DRAWING NO. WM-E003-SK-1

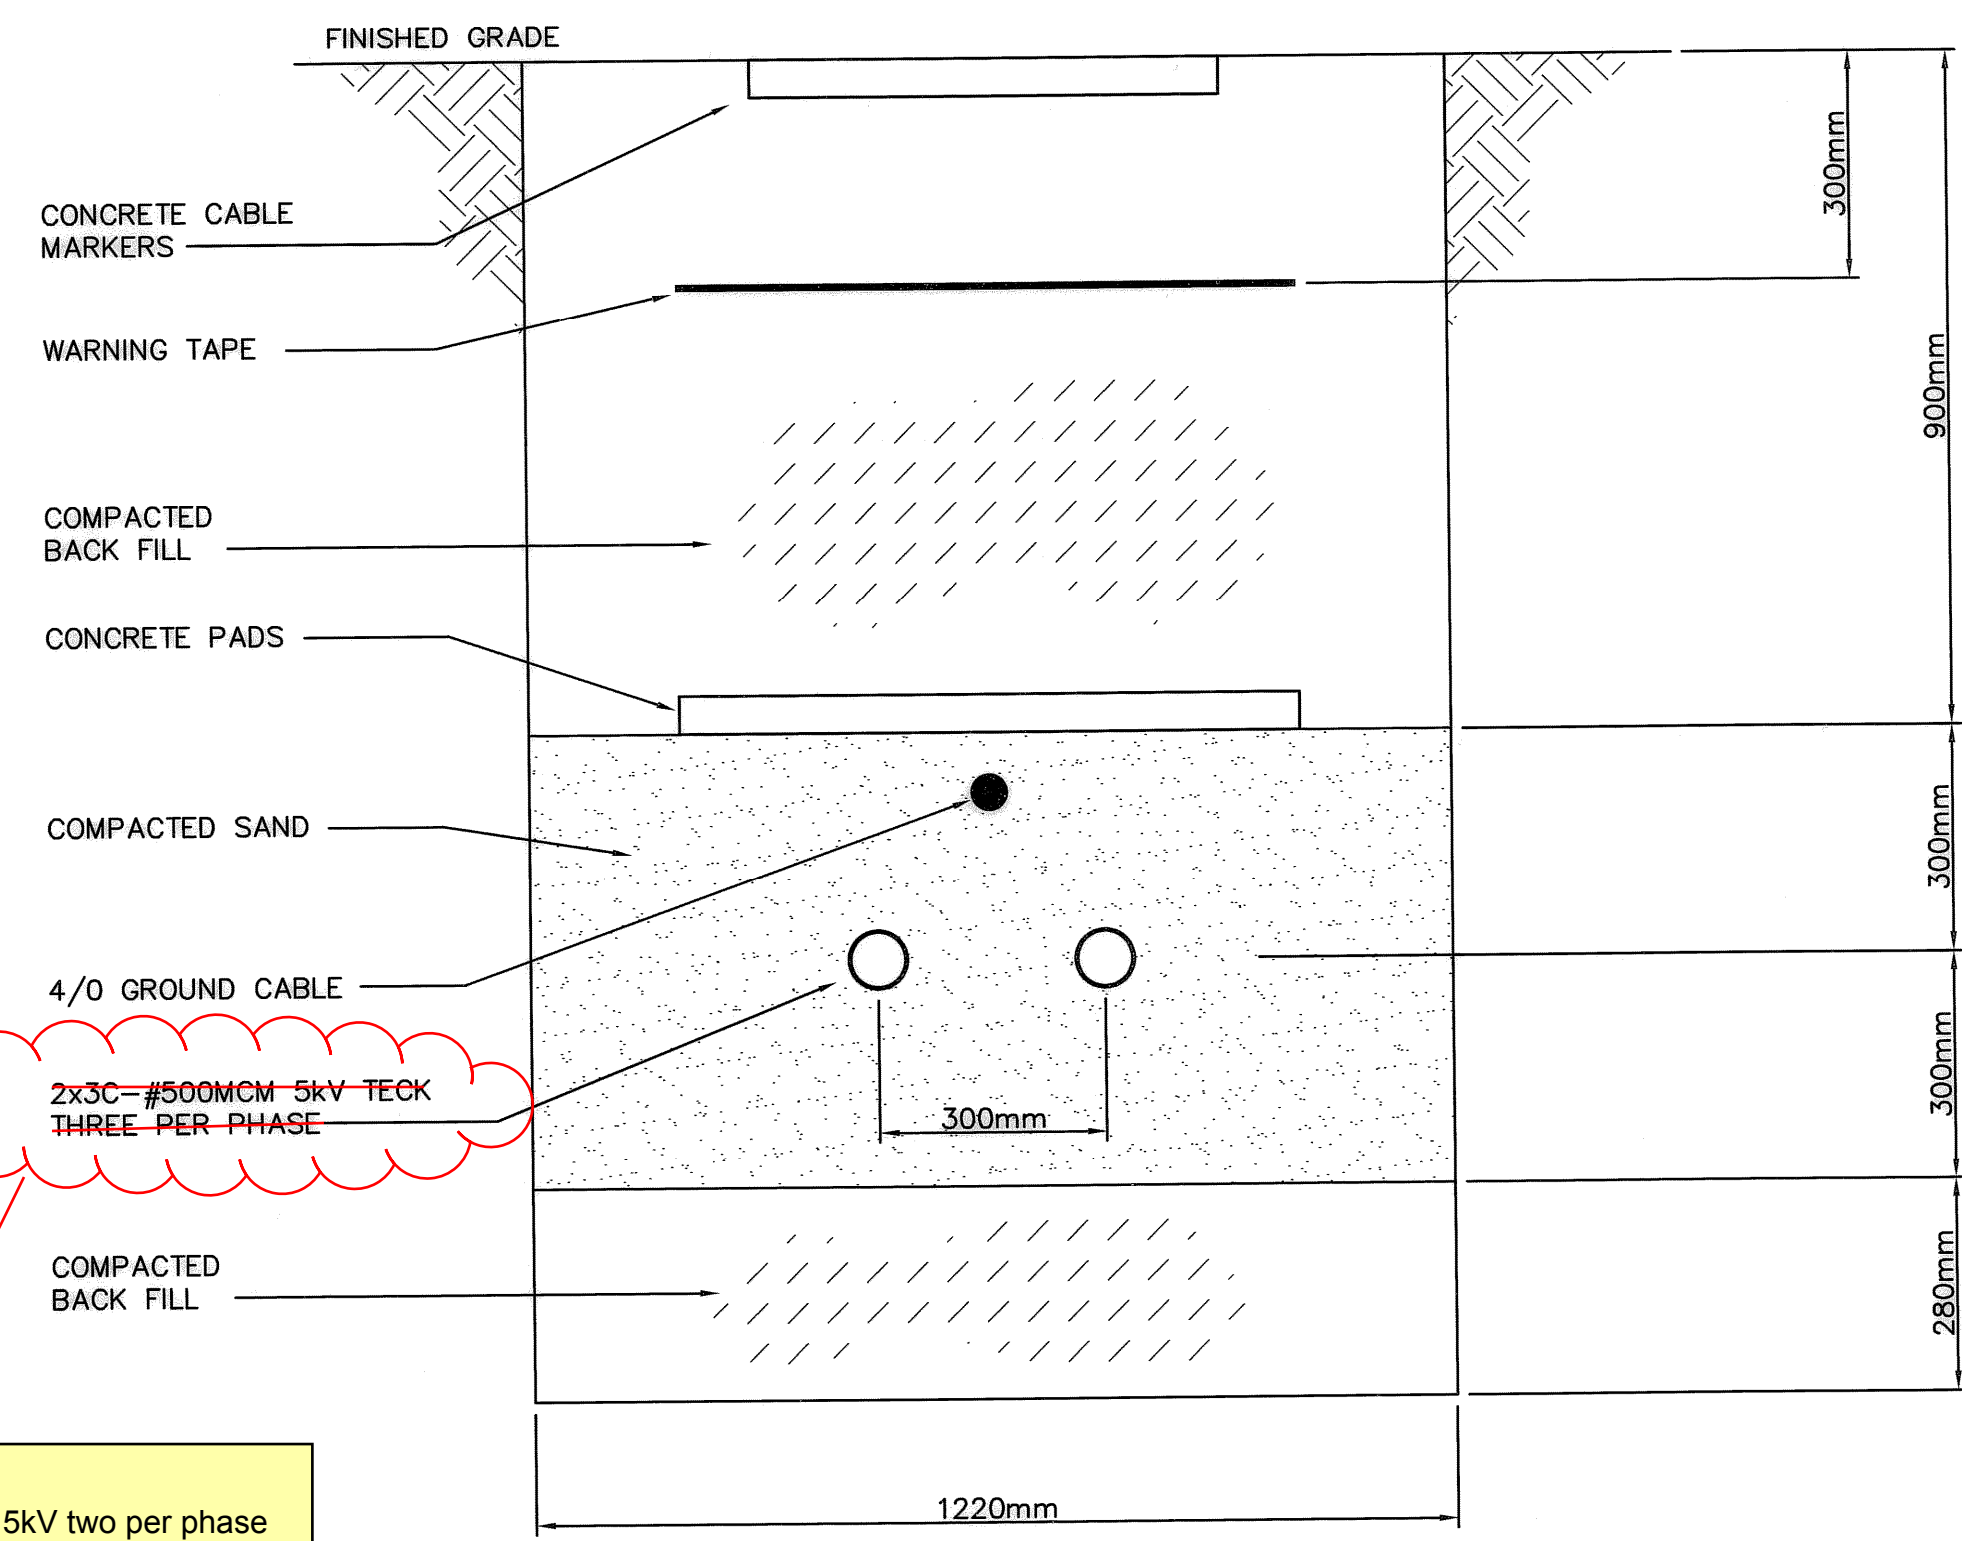
Replace with:  
2x3C - #500MCM 5kV Teck two per phase plus 4/0 ground installed in trench.

Replace with:  
2x3C-#500MCM 5kV two per phase

A SECTION  
E003 SCALE 1:10

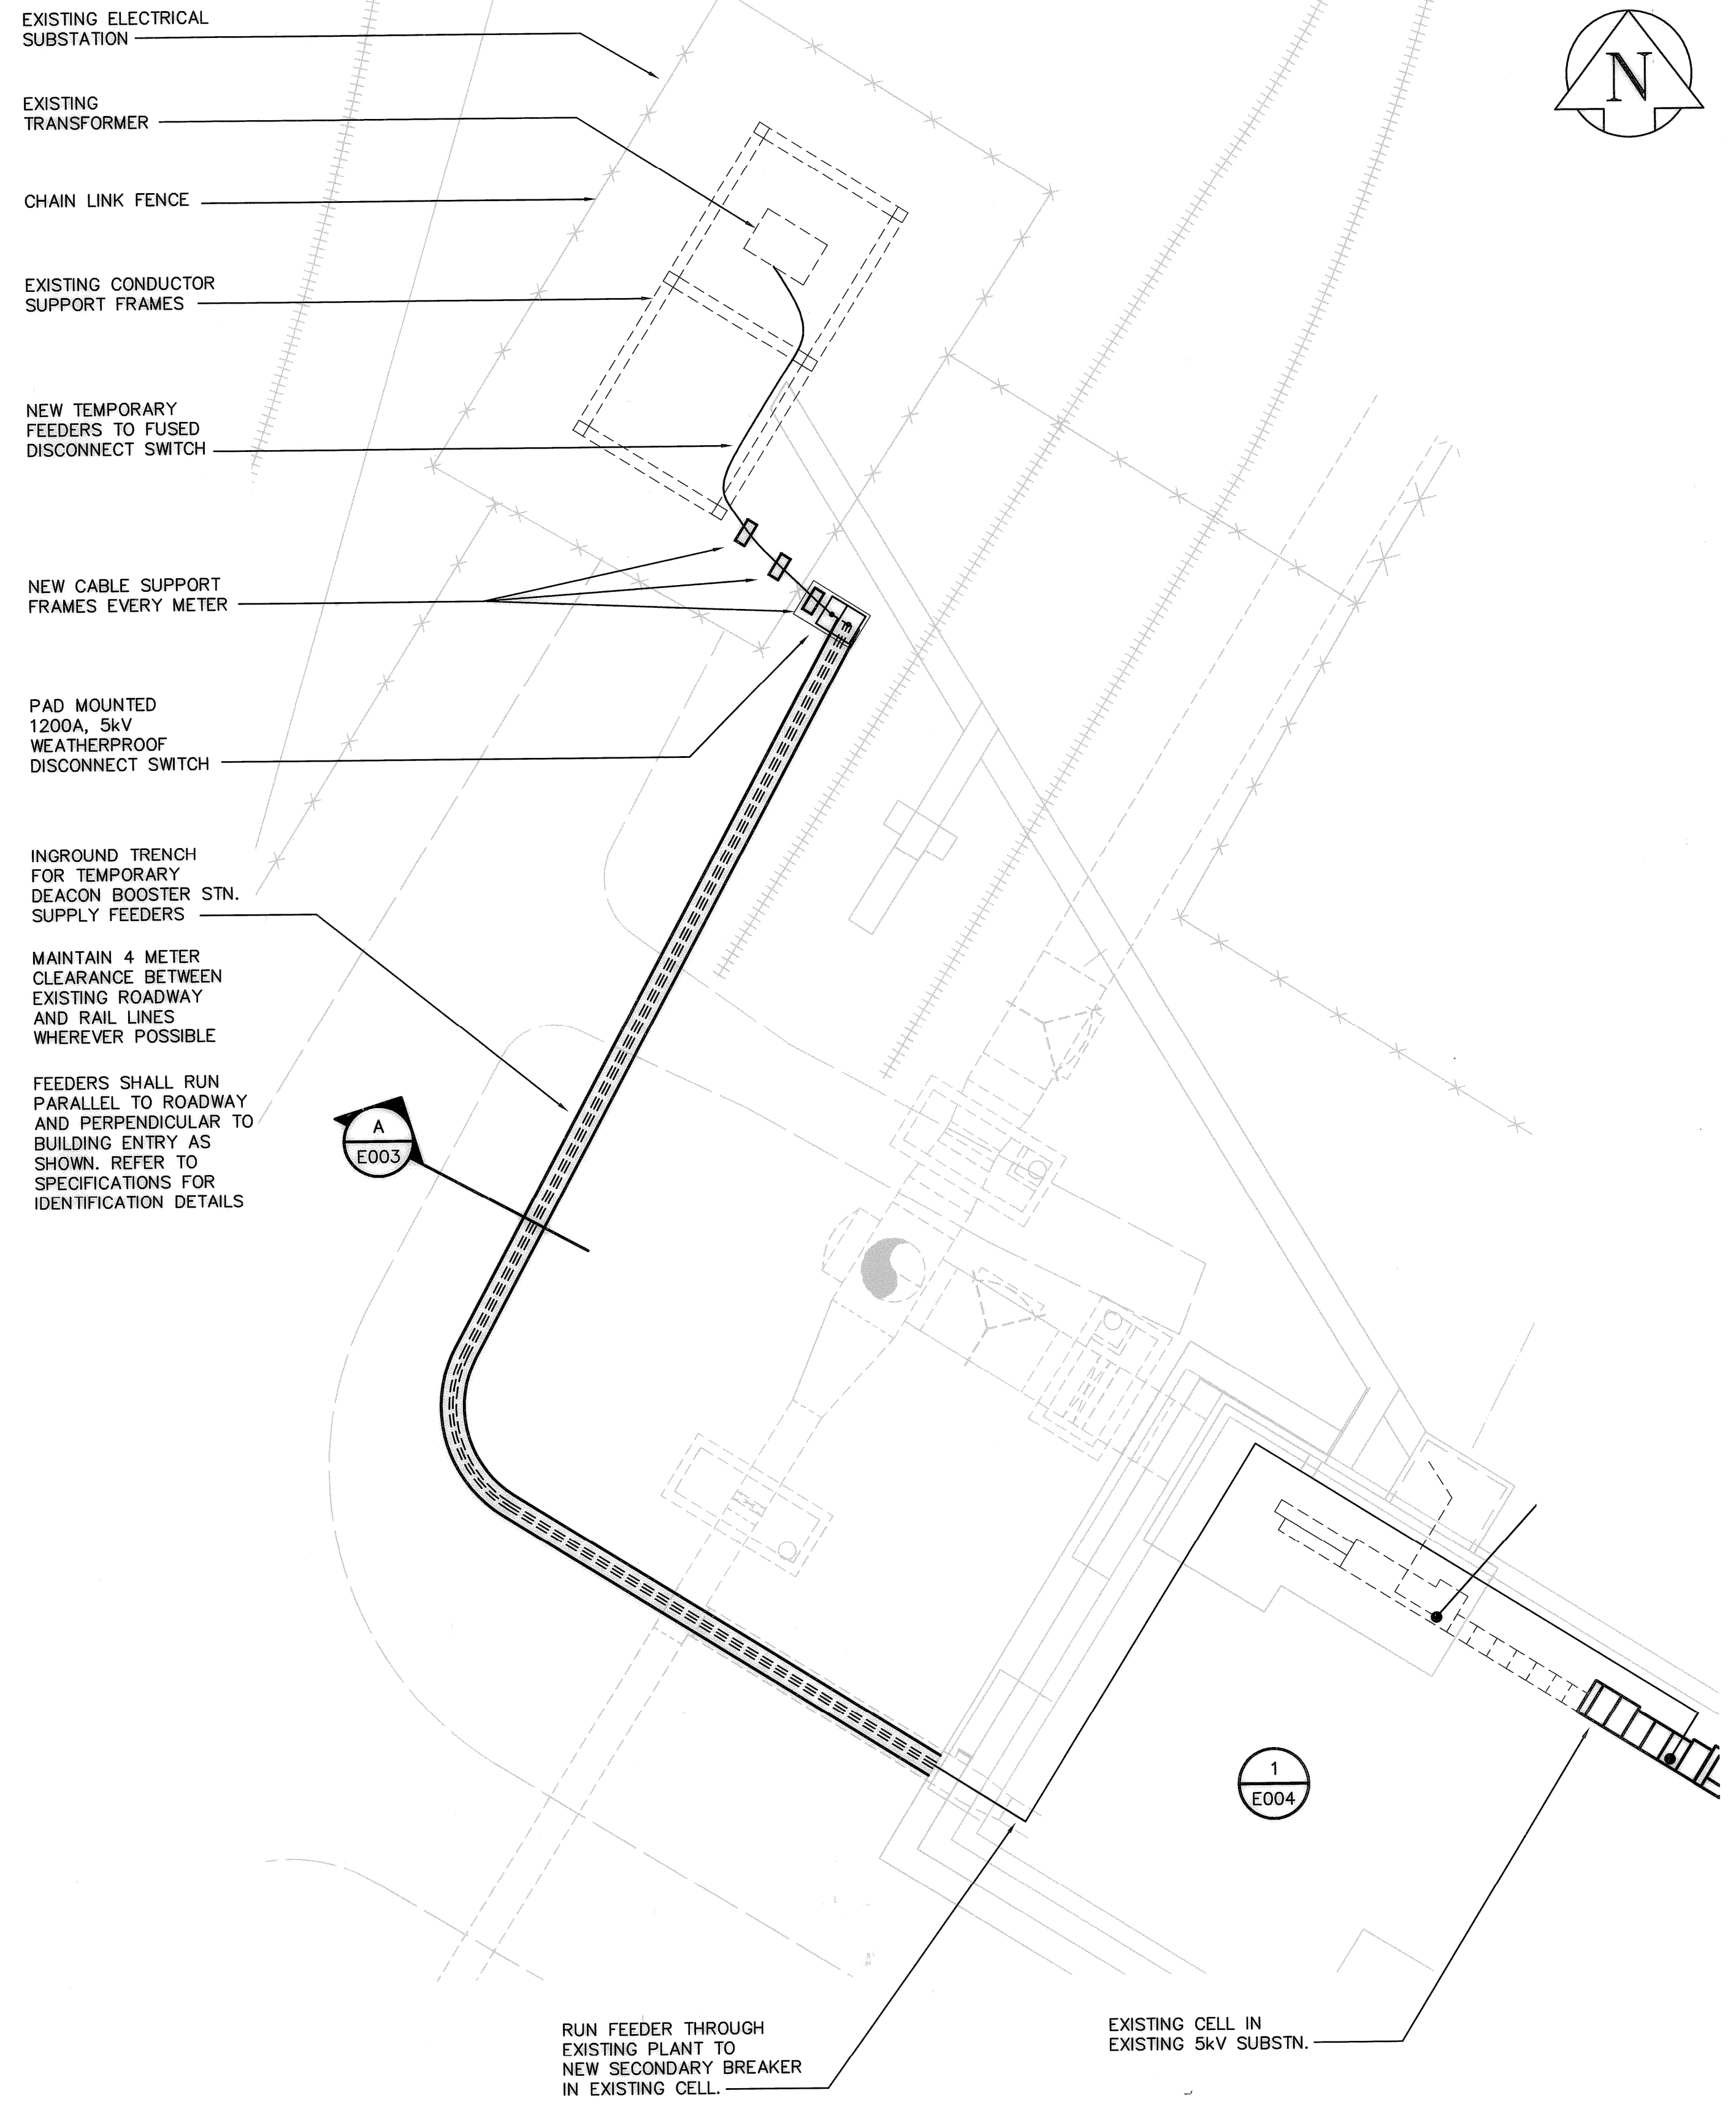
2x3C-#500MCM-5kV-TECK  
THREE PER PHASE PLUS 4/0-GROUND  
INSTALLED IN TRENCH
